Approved Section 75W Modification Application

in respect to MP 09_0153

UTS
DR CHAU CHAK WING BUILDING

MP_09_0153-01-75w submission
Floor plan mark-ups

TITLE
GROUND LEVEL
FLOOR PLAN

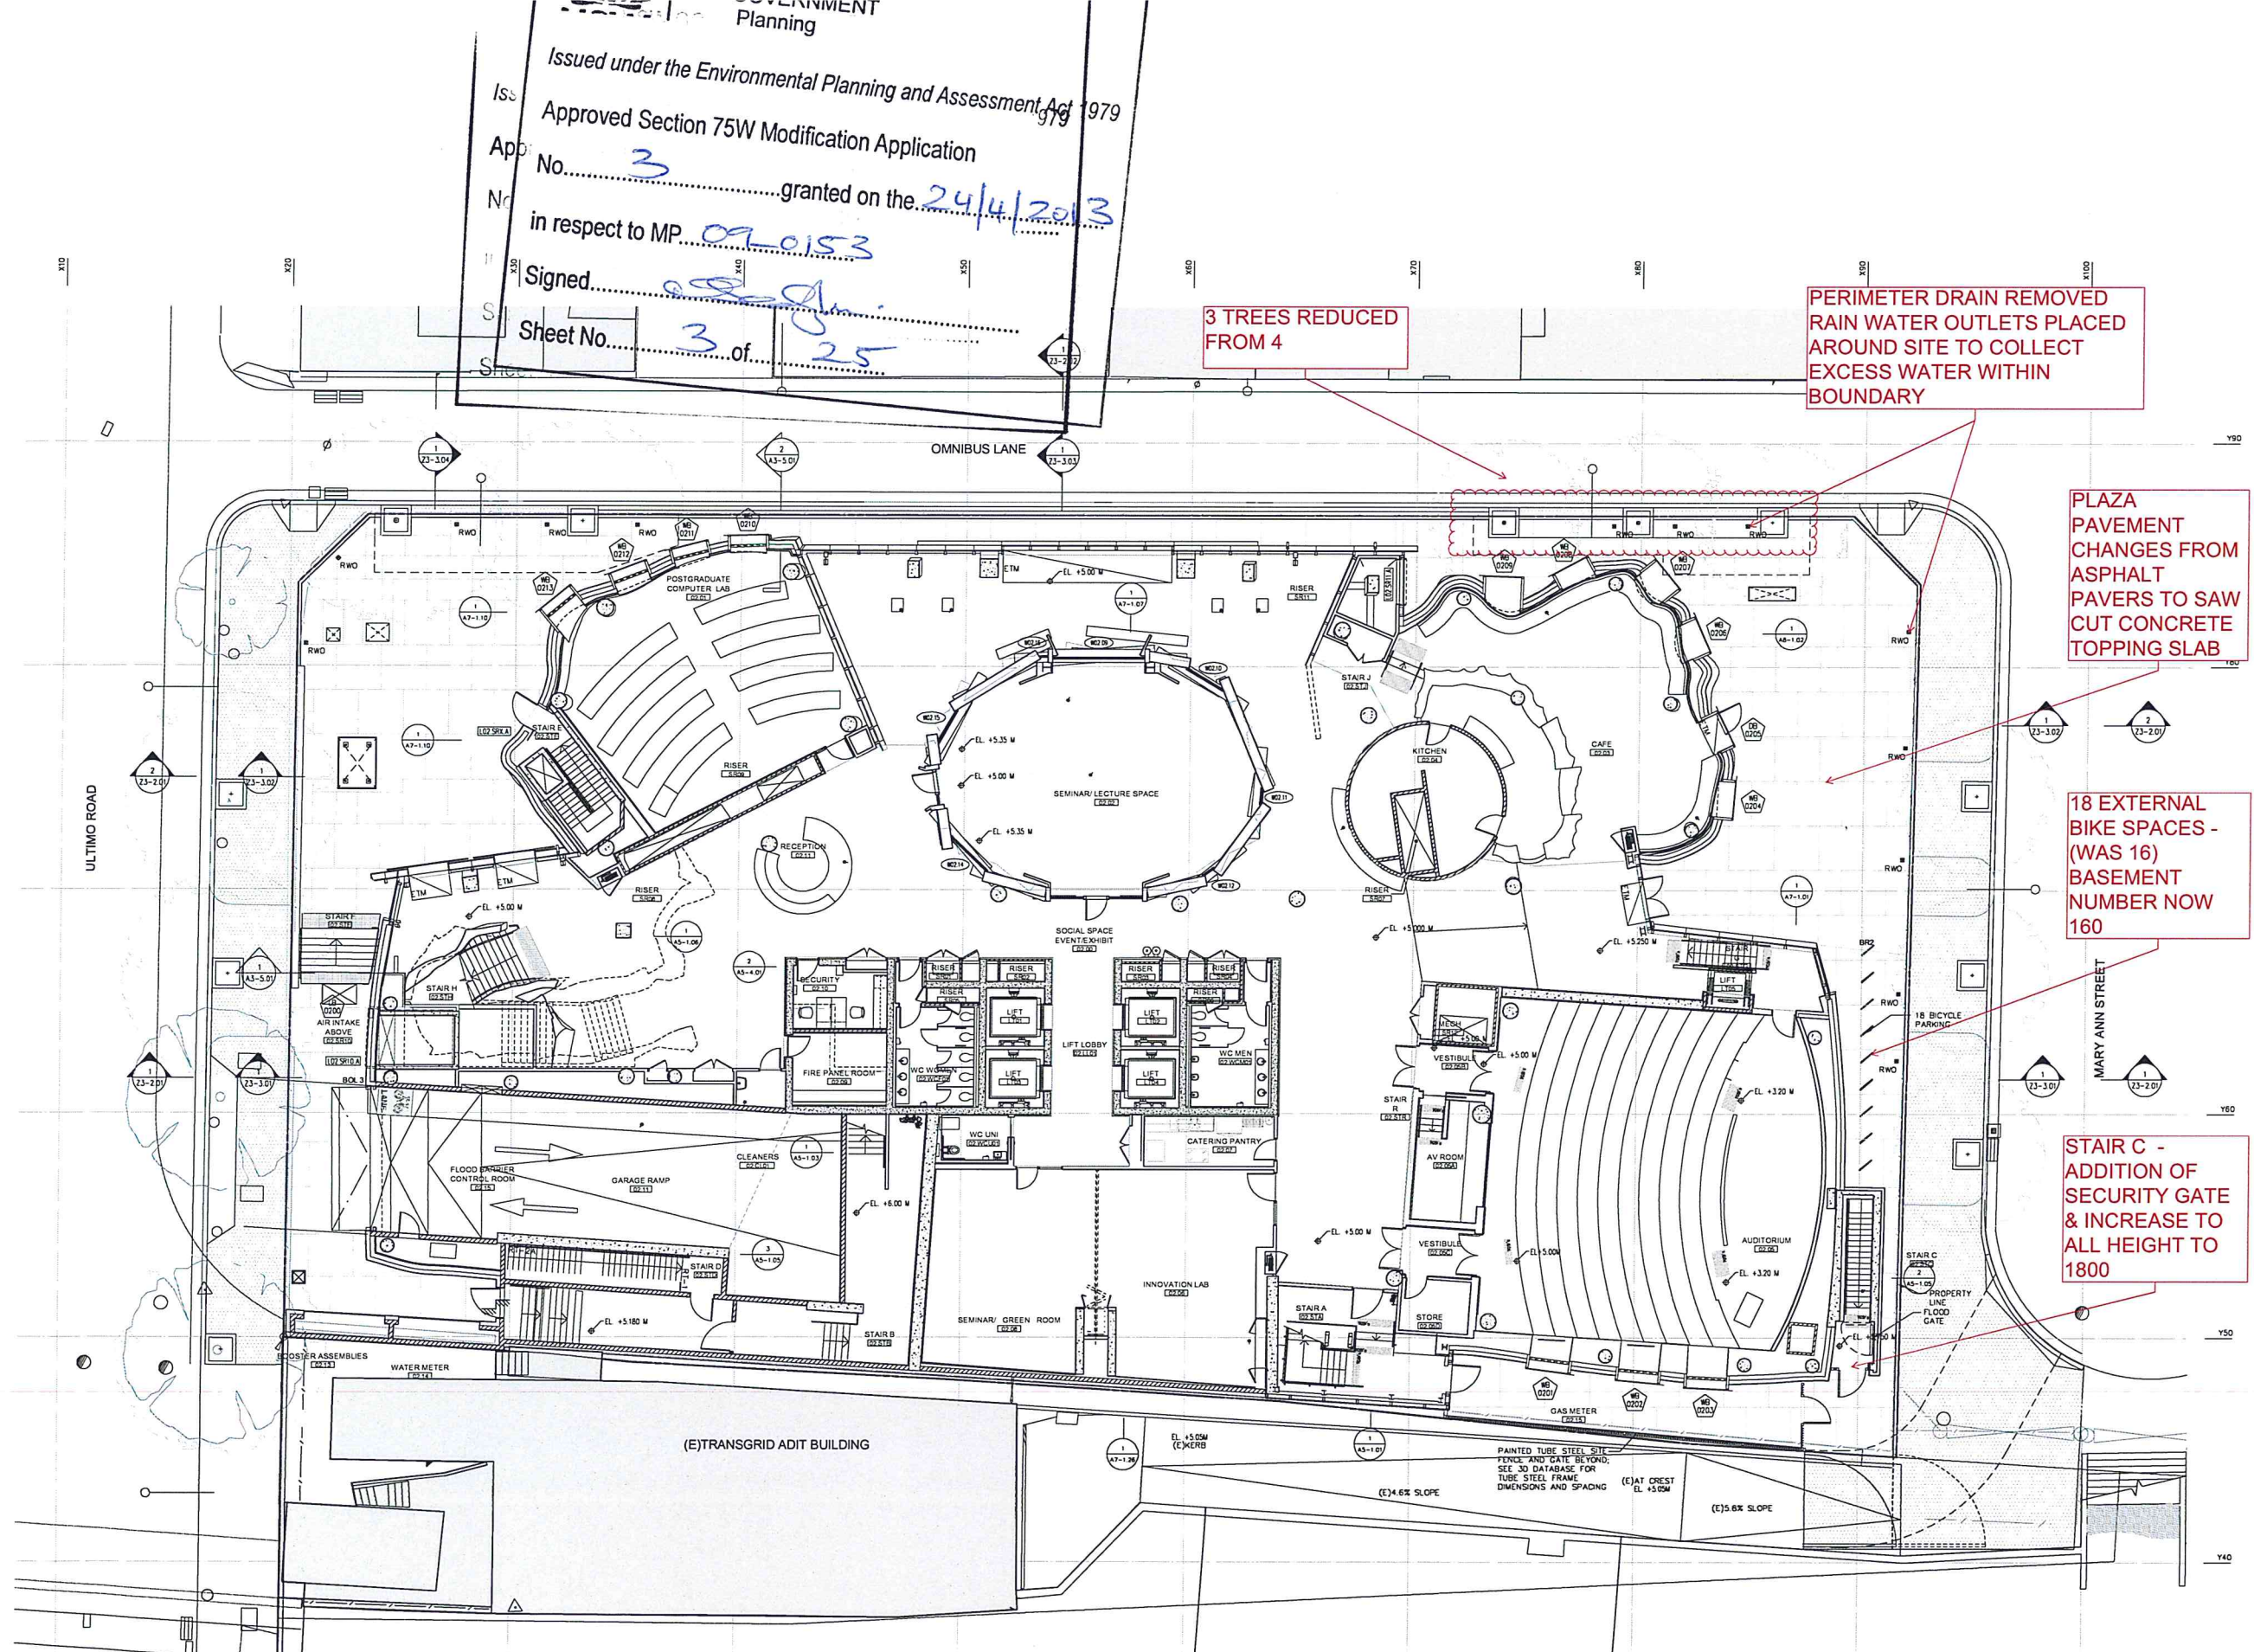
3 TREES REDUCED FROM 4

PERIMETER DRAIN REMOVED
RAIN WATER OUTLETS PLACED
AROUND SITE TO COLLECT
EXCESS WATER WITHIN
BOUNDARY

PLAZA
PAVEMENT
CHANGES FROM
ASPHALT
PAVERS TO SAW
CUT CONCRETE
TOPPING SLAB

18 EXTERNAL
BIKE SPACES -
(WAS 16)
BASEMENT
NUMBER NOW
160

STAIR C -
ADDITION OF
SECURITY GATE
& INCREASE TO
ALL HEIGHT TO
1800

Level 4 - changes to fly bys and
brick geometry

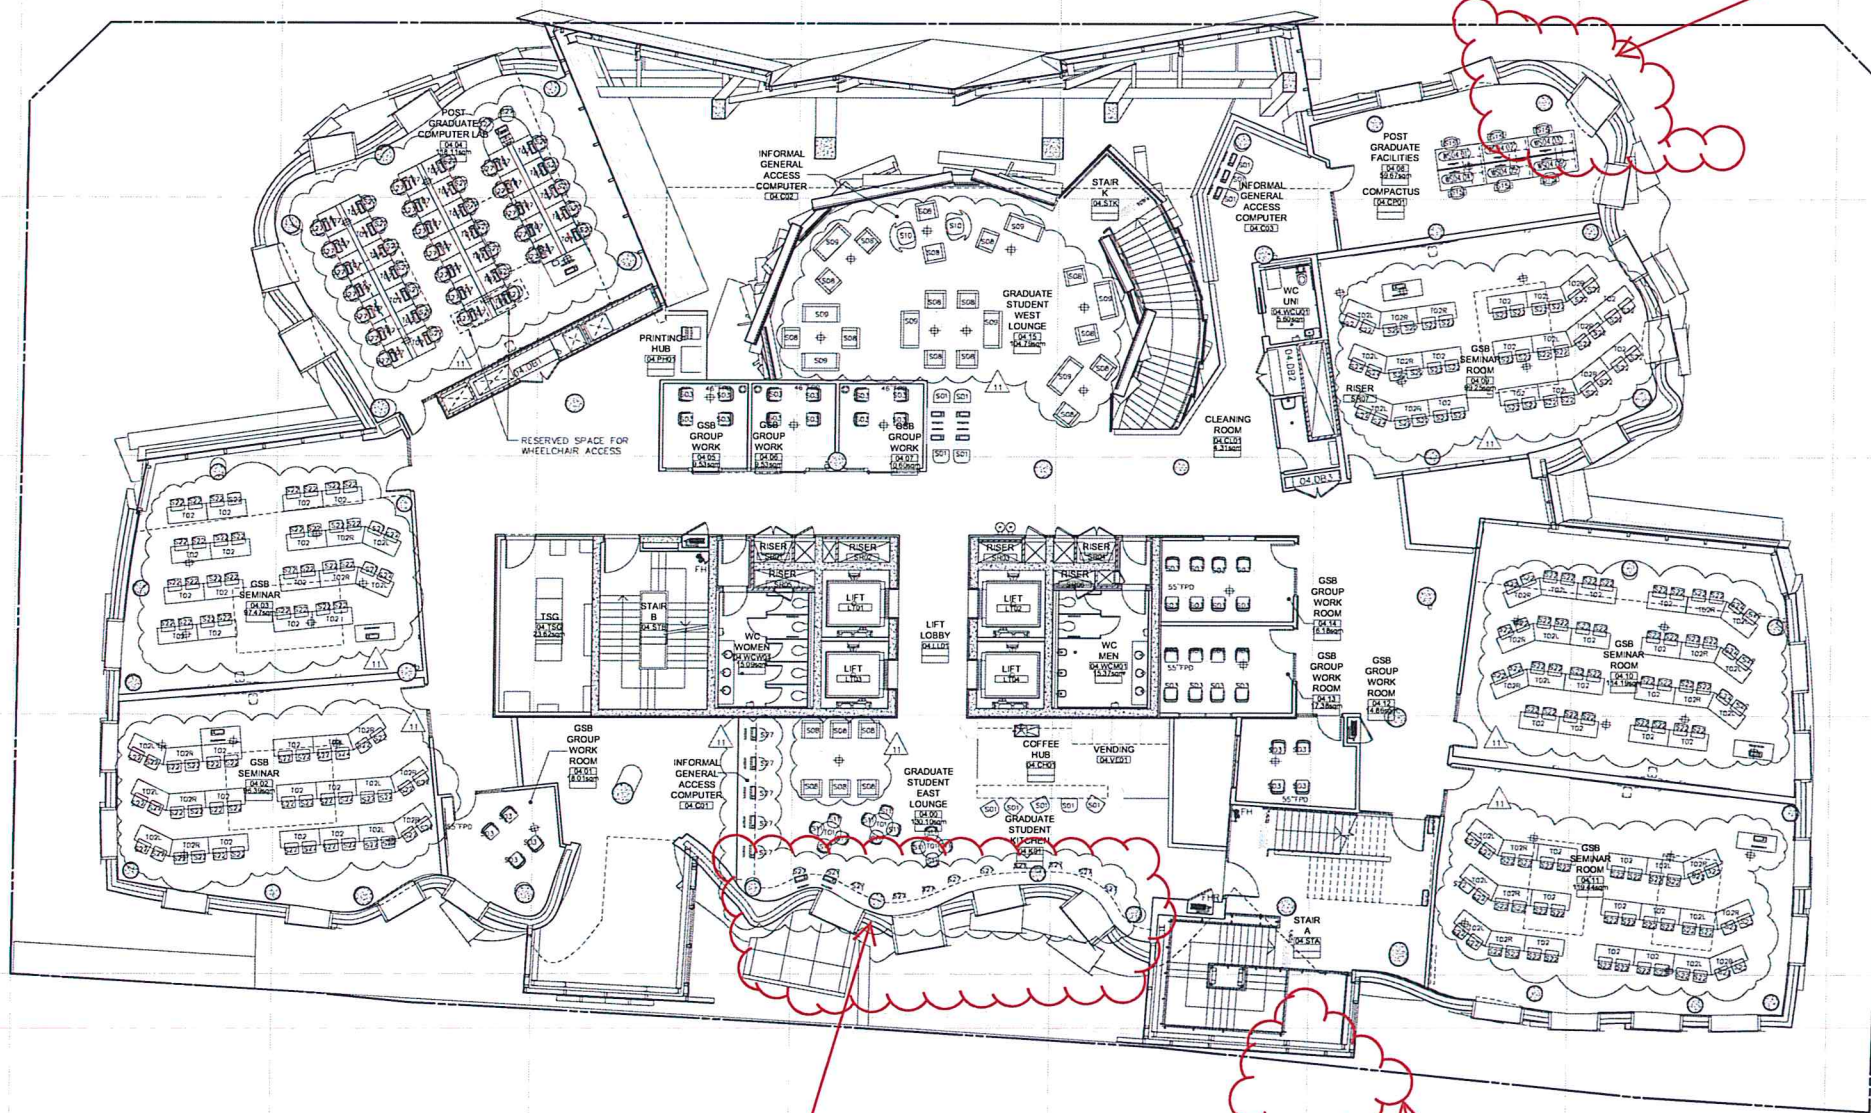
Brickwork
geometry slightly
flattened.

Brickwork
geometry slightly
flattened.

Fly by reduced

Level 6 - changes to brick geometry

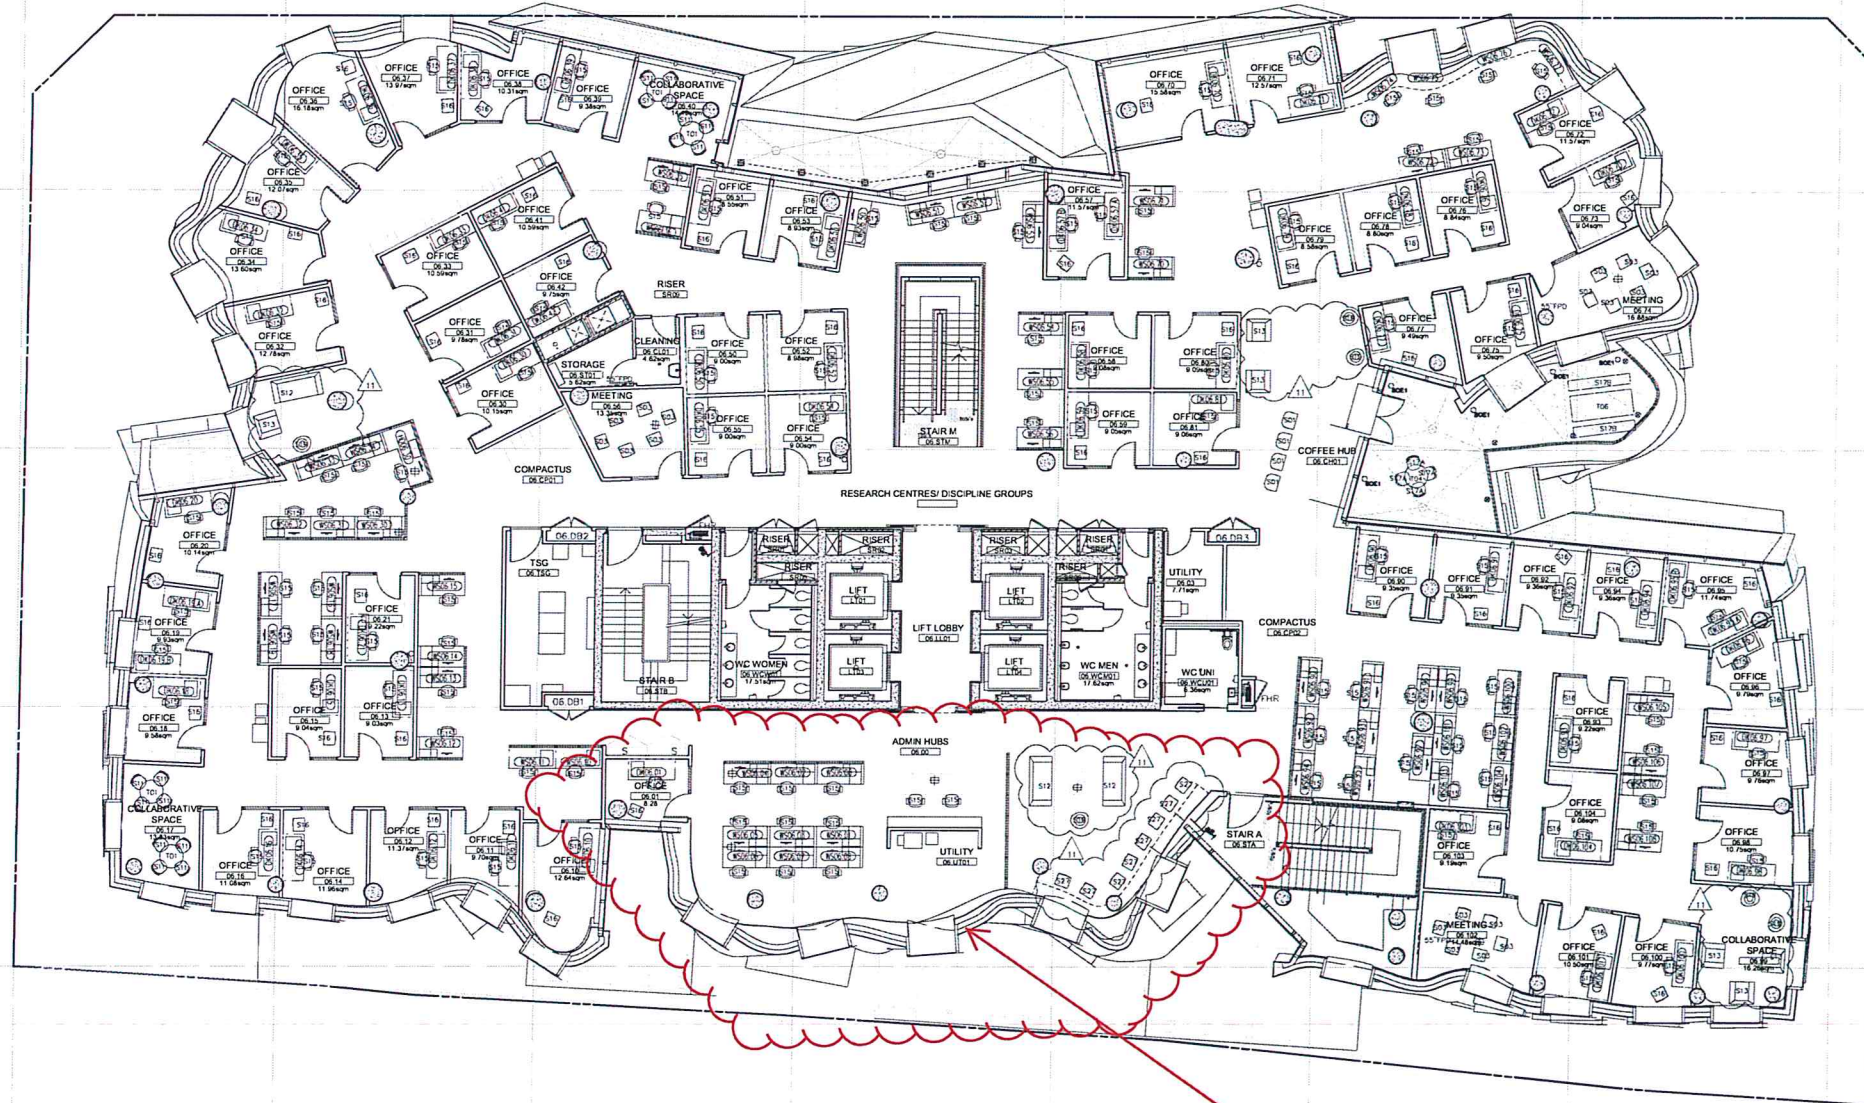
Brickwork geometry
amended slightly.

Level 7 - changes to brick geometry

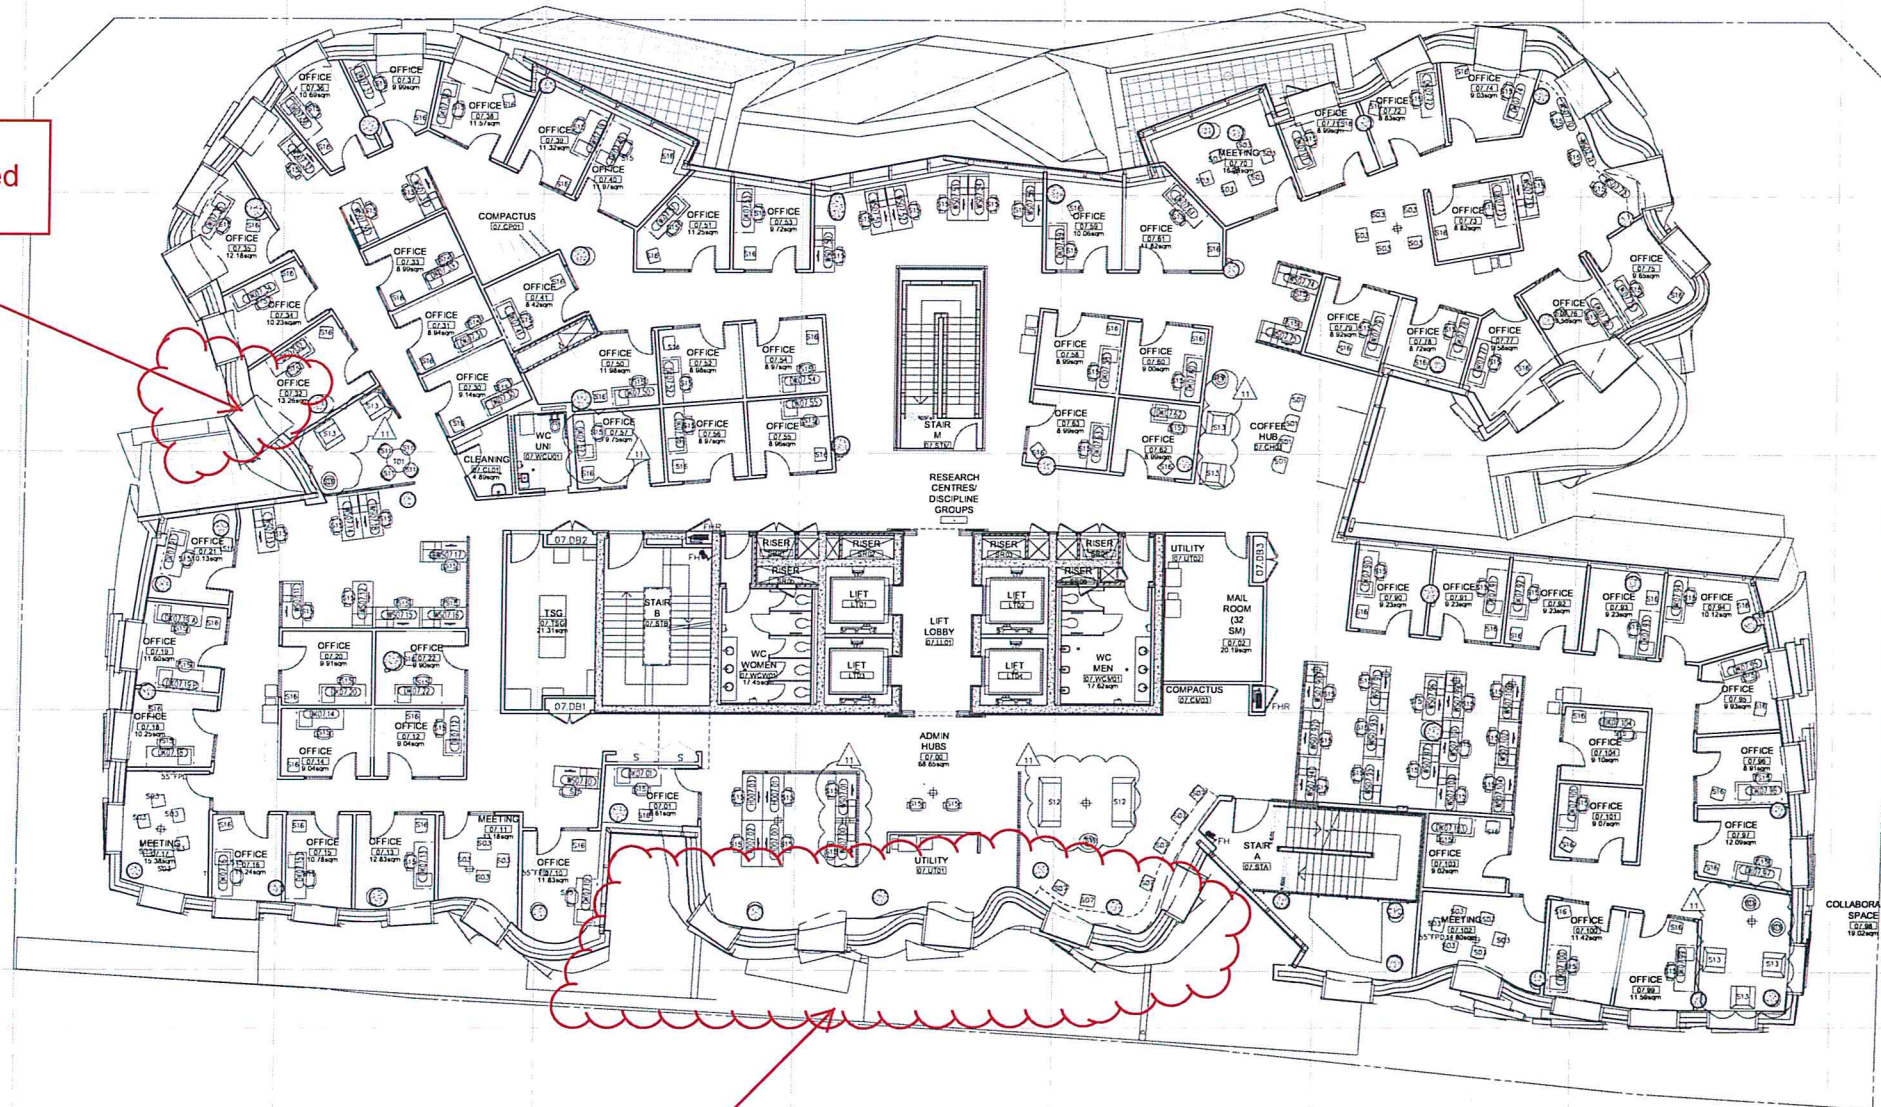
Brickwork
geometry levelled
slightly.

Brickwork geometry
amended slightly.
